**EIGHTH AMENDMENT TO AGREEMENT BETWEEN THE CITY OF LEAGUE CITY
AND TBG PARTNERS**

Request for Additional Services No. 8
Client: City of League City
Project: Bay Colony Park
Location: Ervin Rd., League City, Texas
TBG Project: #H19144

EXHIBIT A-1

EXHIBIT A-2

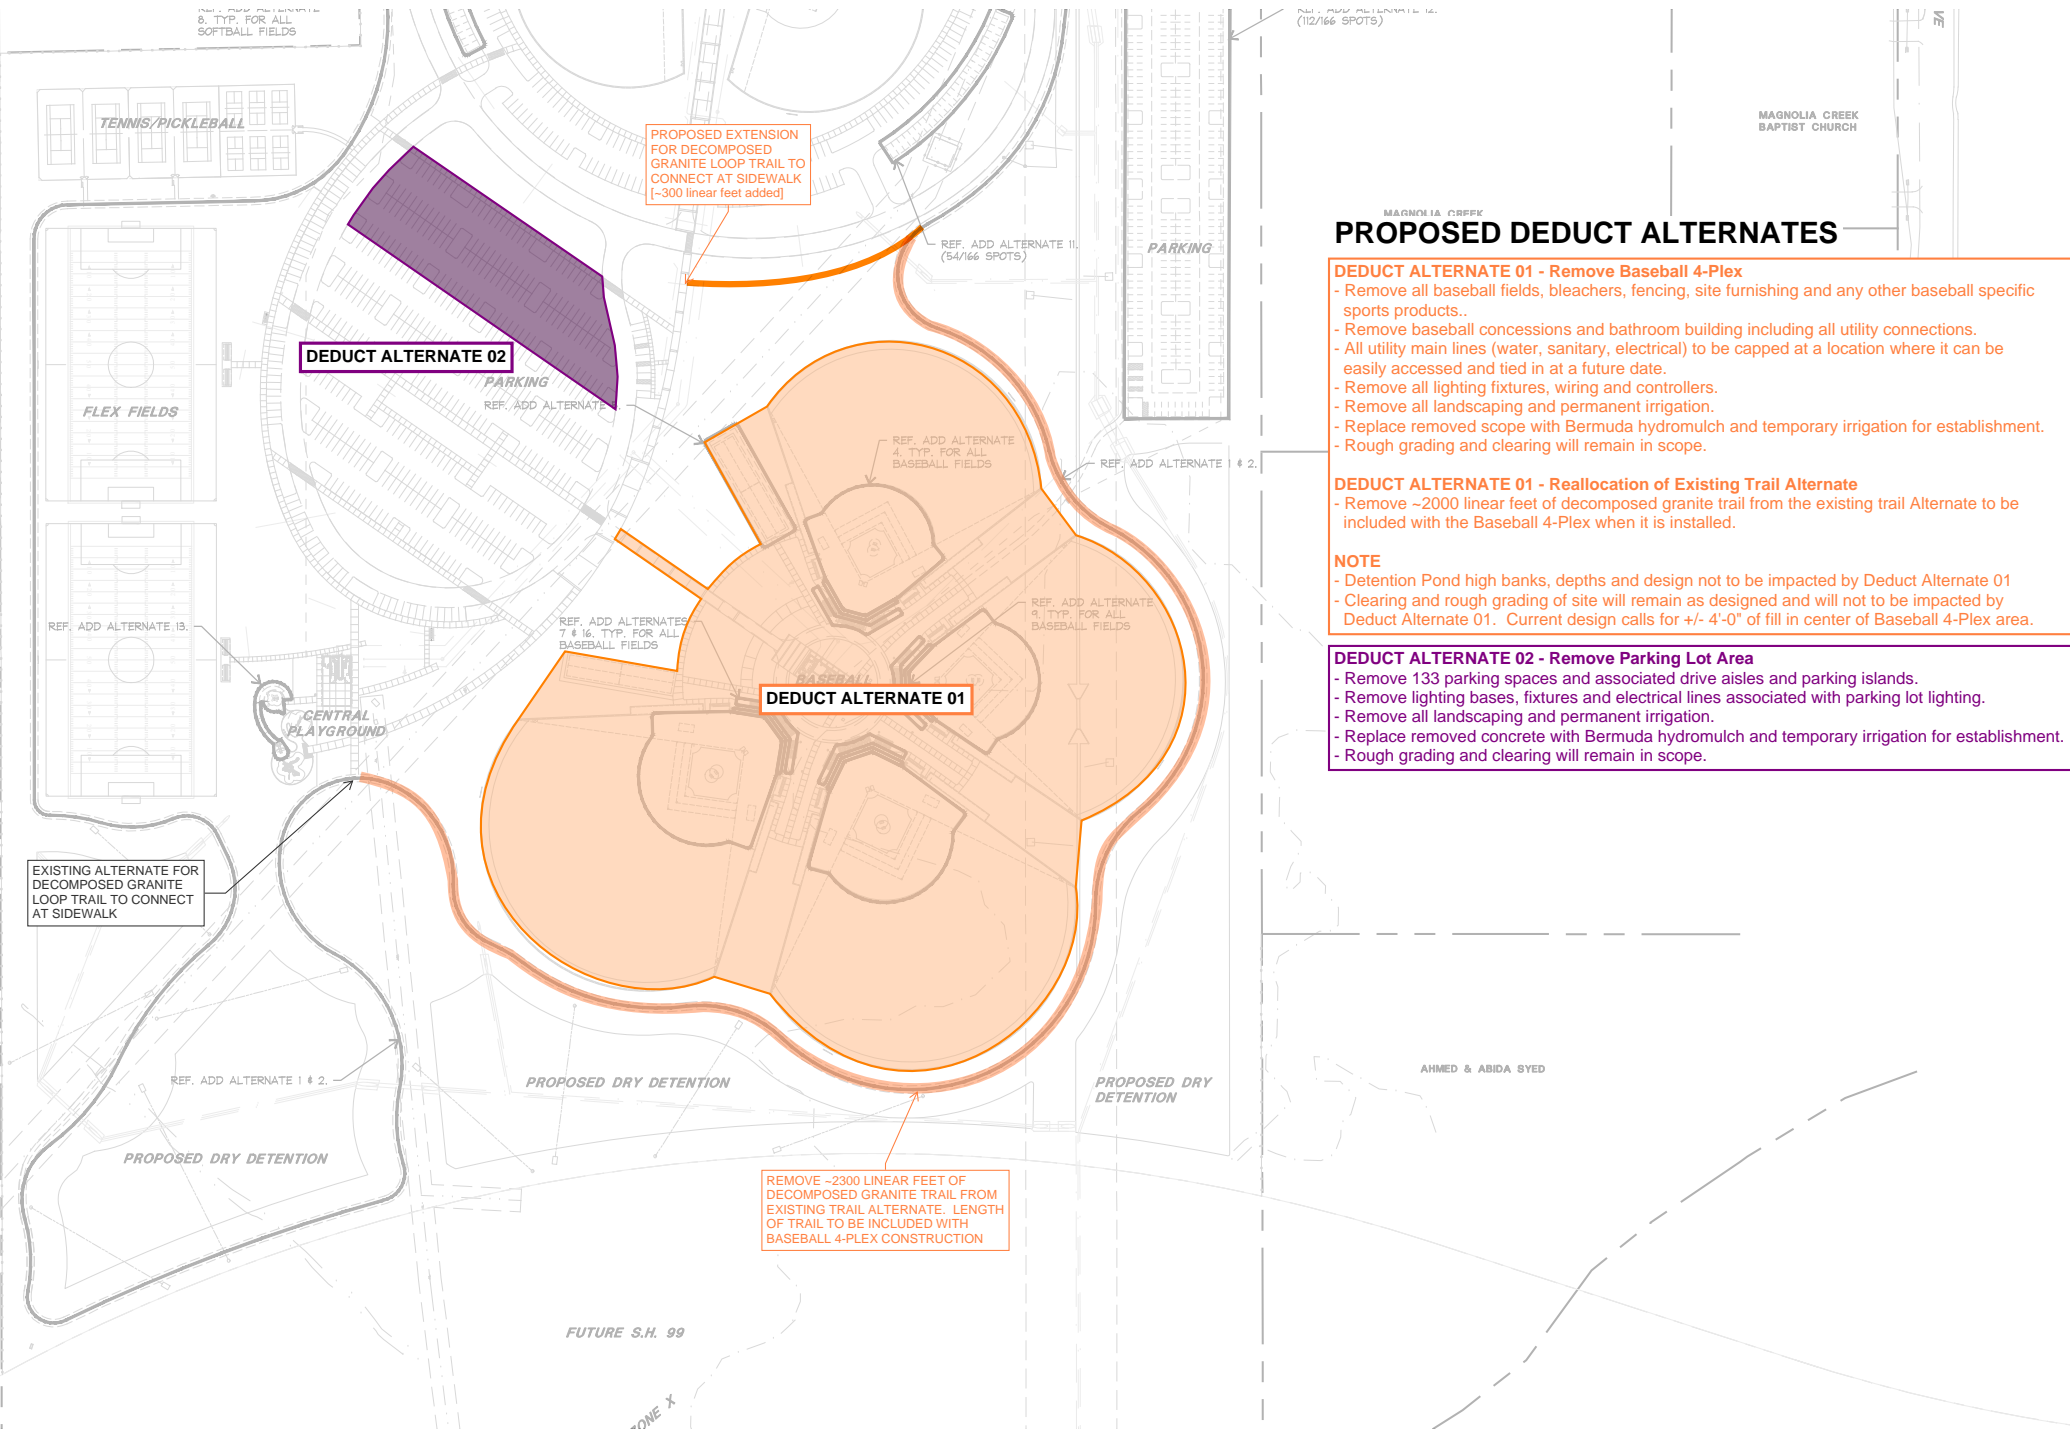
<u>Alternate:</u>	<u>Description:</u>	<u>Estimated Impact to Schedule:</u>	<u>Estimated Construction Cost:</u>	<u>Estimated Design Fees:</u>	<u>Total Estimated Alternate Cost:</u>
Deduct Alternate 01	** Removal of Baseball 4-Plex from Scope	4 weeks	\$ (9,154,722.00)	See Below	See Below
<p>The following items will be affected by the removal of scope associated with this alternate:</p> <ul style="list-style-type: none"> - Baseball fields, bleachers, fencing, site furnishing and all Baseball specific sports products. - Baseball Concession and Bathroom Building and all utility connections - All utility main lines (water, sanitary, electrical) will be capped at a location where it can be easily accessed and tied in at a future date. - Removal of all lighting fixtures, wiring and controllers. - Removal of all landscaping and to be replaced with hydroseed with temporary irrigation until establishment. - Clearing and rough grading will remain in base scope. Fine grading will not be included for area where Baseball Complex was removed. - Removal of 2000 linear feet of decomposed granite trail from Trail Alternate

Deduct Alternate 02	Removal of 133 Spaces from Parking Lot	4 weeks	\$ (338,561.46)	See Below	See Below
<p>The following items will be affected by the removal of scope associated with this alternate:</p> <ul style="list-style-type: none"> - Removal of concrete for parking lot drive aisle and parking stalls to be replaced with hydroseed and temporary irrigation until establishment. - Removal of all lighting fixtures, wiring and controllers associated with parking area to be removed. - Clearing and rough grading will remain in base scope. Fine grading will not be included for area where Baseball Complex was removed. 					
Totals:		8 weeks	\$ (9,493,283.46)	\$ 63,300.00	\$ (9,429,983.46)

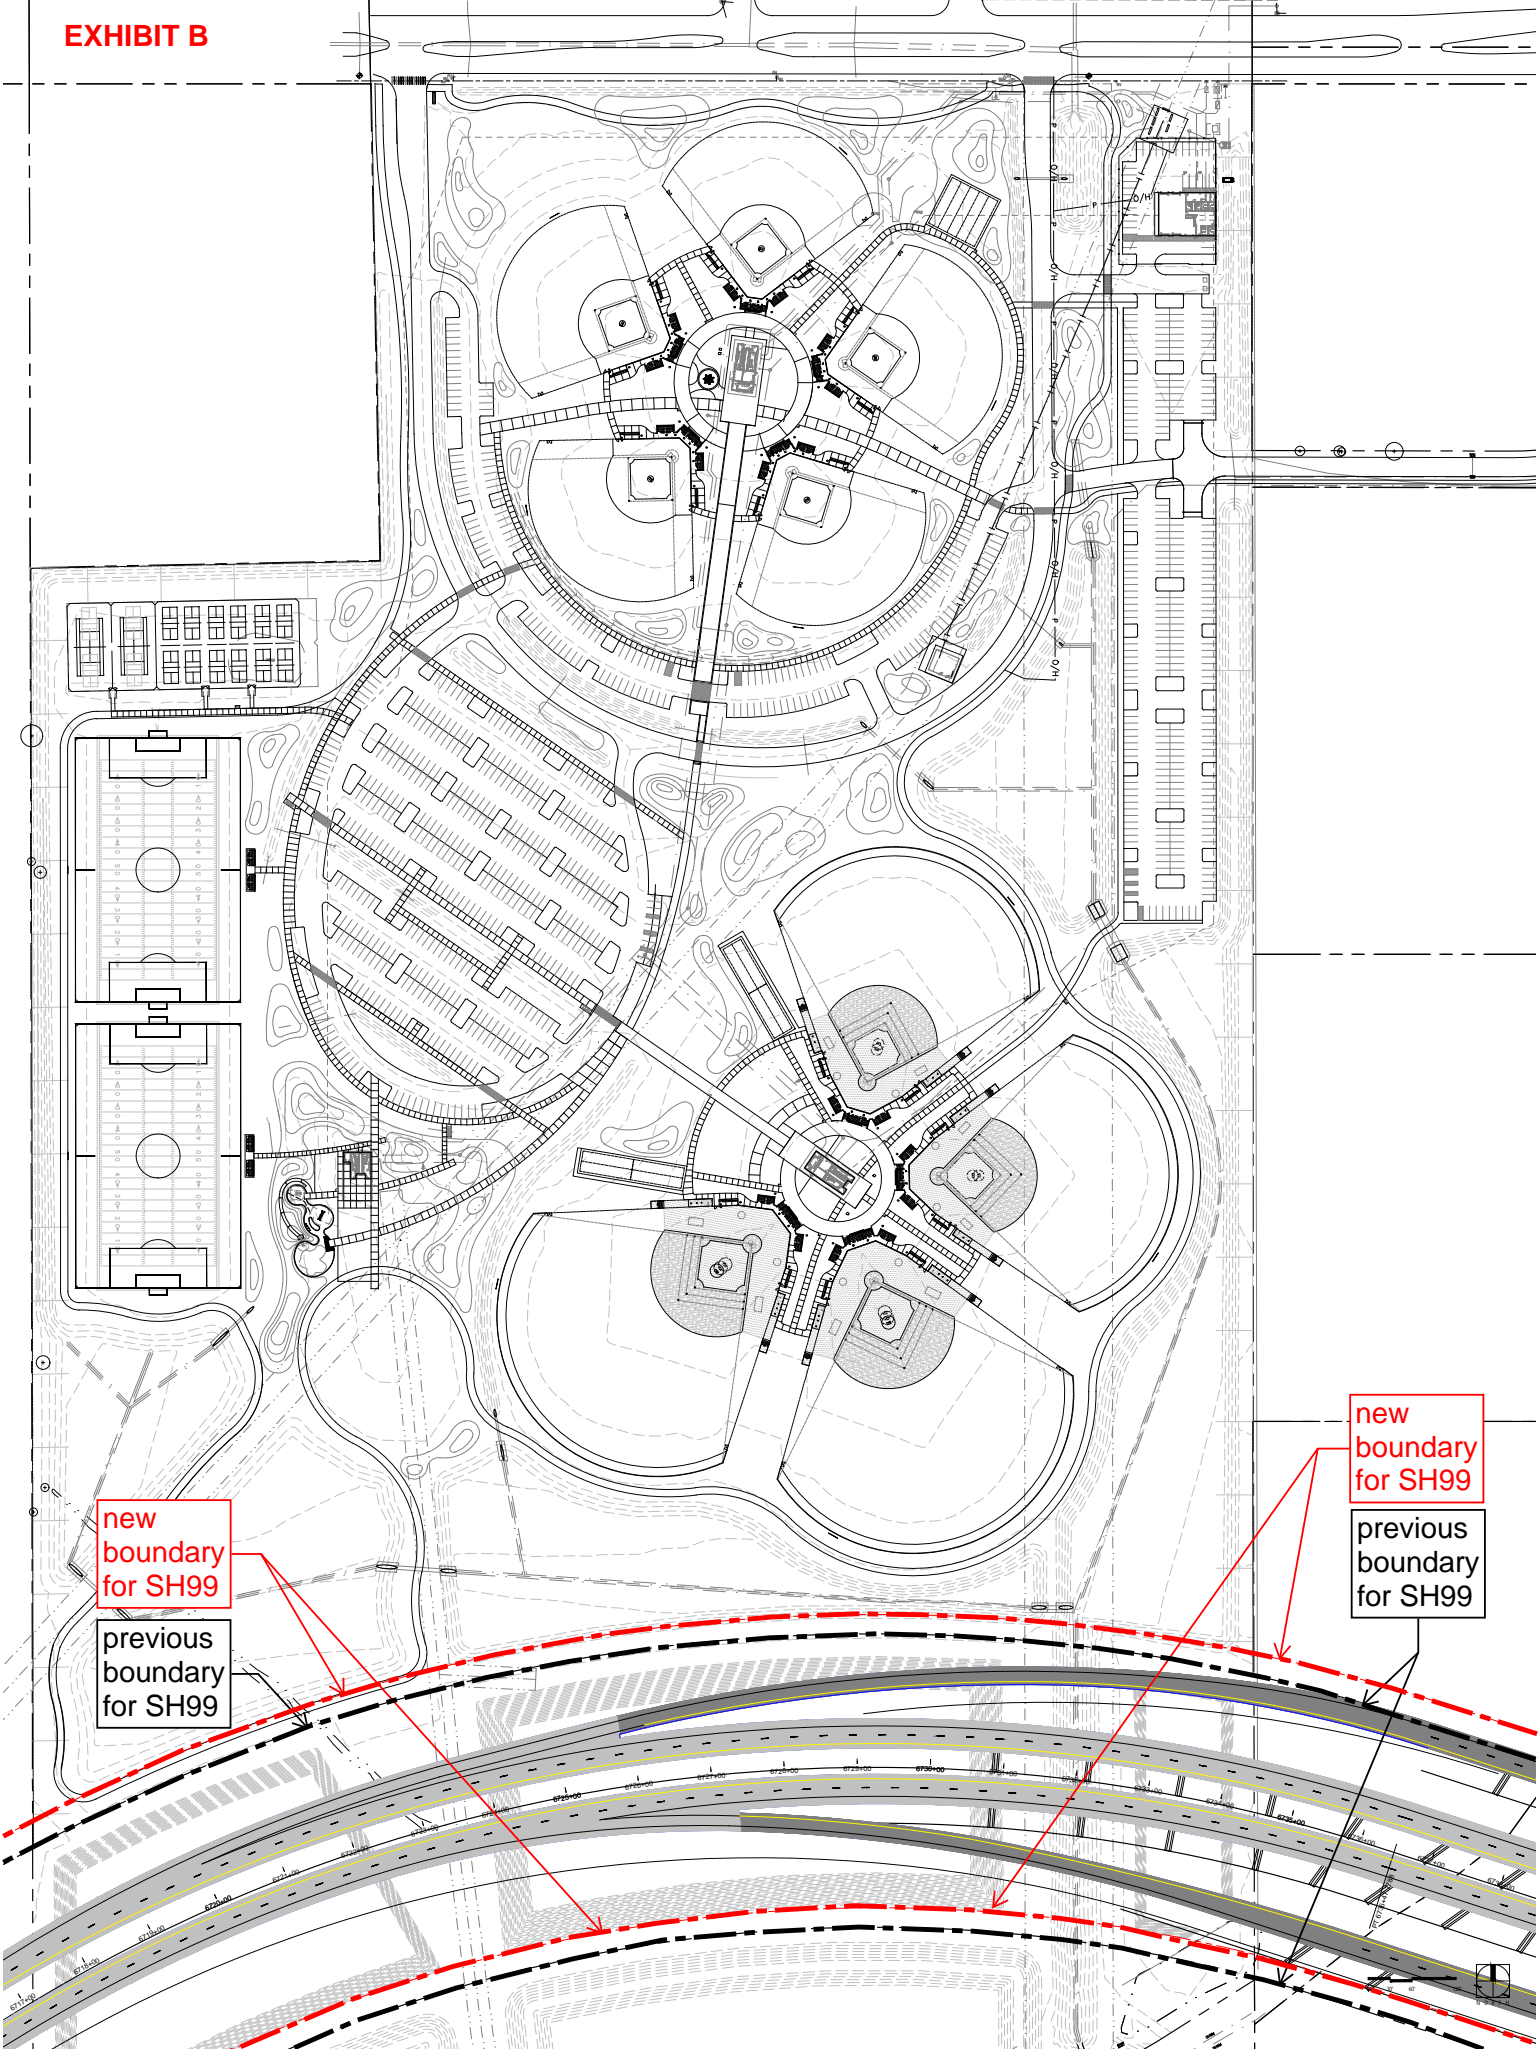
- DEDUCT ALTERNATE 01 - Remove Baseball 4-Plex**
- Remove all baseball fields, bleachers, fencing, site furnishing and any other baseball specific sports products..
 - Remove baseball concessions and bathroom building including all utility connections.
 - All utility main lines (water, sanitary, electrical) to be capped at a location where it can be easily accessed and tied in at a future date.
 - Remove all lighting fixtures, wiring and controllers.
 - Remove all landscaping and permanent irrigation.
 - Replace removed scope with Bermuda hydromulch and temporary irrigation for establishment.
 - Rough grading and clearing will remain in scope.

- DEDUCT ALTERNATE 01 - Reallocation of Existing Trail Alternate**
- Remove ~2000 linear feet of decomposed granite trail from the existing trail Alternate to be included with the Baseball 4-Plex when it is installed.

- NOTE**
- Detention Pond high banks, depths and design not to be impacted by Deduct Alternate 01
 - Clearing and rough grading of site will remain as designed and will not be impacted by Deduct Alternate 01. Current design calls for +/- 4'-0" of fill in center of Baseball 4-Plex area.

- DEDUCT ALTERNATE 02 - Remove Parking Lot Area**
- Remove 133 parking spaces and associated drive aisles and parking islands.
 - Remove lighting bases, fixtures and electrical lines associated with parking lot lighting.
 - Remove all landscaping and permanent irrigation.
 - Replace removed concrete with Bermuda hydromulch and temporary irrigation for establishment.
 - Rough grading and clearing will remain in scope.
